RE: Packer Setting Depth Exception

Injection Authority: Administrative Order SWD-1646 (dated August 12, 2016)
Permitted Interval: Cisco formation; approximately 7530 feet to approximately 8700 feet
Choate Davis 14 State SWD Well No. 2 (API 30-015-43628)
Unit E, Sec 14, T18S, R27E, NMPM, Eddy County, New Mexico

RE: Request Variance to 100' SWD Packer Rule
Choate Davis 14 State #2 - API#: 30-015-43628
State SWD order: SWD-1646
Unit Letter "E" Section 14 T18S R27E
Eddy County, New Mexico

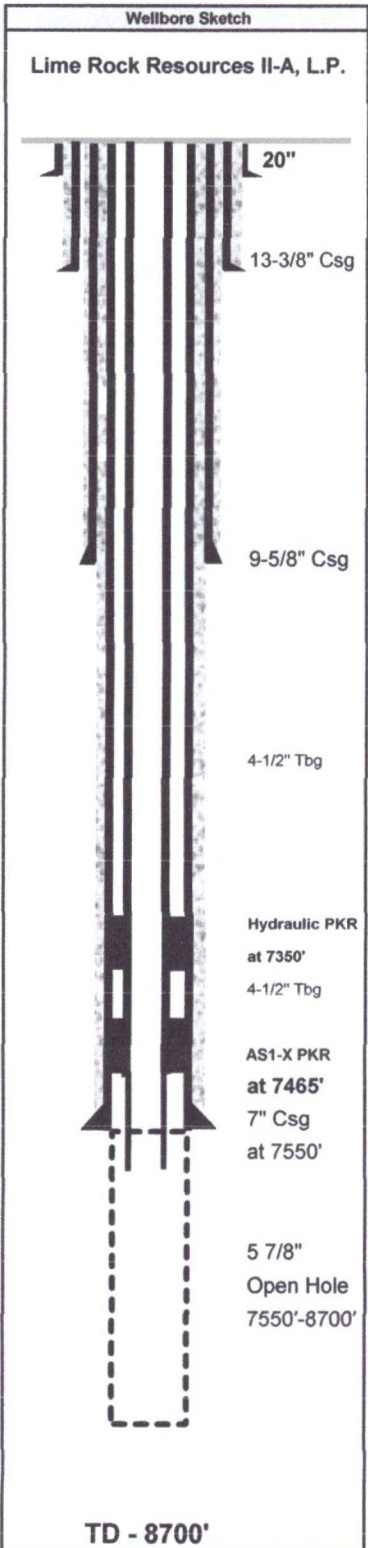
On 4/27/17, Lime Rock set a 7" x 3-1/2" nickle plated AS1-X injection PKR at 7465' with on/off tool and pump out plug, and tail pipe below the 7" shoe at 7550'. See the attached wellbore diagram. Lime Rock then spent 2 weeks attempting to locate why the 7" csg would not hold a pressure test. The leak was so small that the results were indeterminate. A csg inspection log run on 5/9/17 was also indeterminate. However, it was determined that the 7" casing would hold a pressure test above 7365'.

Therefore, in an effort to insure the isolation of high pressure water and possibly H2S coming from the open hole injection interval, 7550'-8700', Lime Rock would like to complete this SWD well with the additional safety features as follows:

Run the seal assembly for the AS1-X injection pkr and a DLH 7" x 3-1/2" hydraulic PKR on 4-1/2" 11.6# duolined tbg. Sting into AS1-X pkr at 7465' & set hydraulic PKR at 7350' with 4-1/2" duolined tbg between PKRs and landed at surface. Release rig. Schedule MIT test and step rate test.

For the reasons stated in the application and because it appears that correlative rights are protected, waste will not occur and this modification will not endanger any fresh water aquifer or the environment, the exception is granted. The upper packer location within this well shall not be set higher than 200 feet above the top of the open-hole interval unless the operator receives written approval from the Division Director. This exception is applicable only with the use of the two-packer system as detailed in the Lime Rock correspondence dated May 17, 2017. **The Division also stipulates that future repositioning of the upper packer above the current will not be considered and that the operator will be required to remediate the 7-inch production casing to resolve the casing integrity issue.**
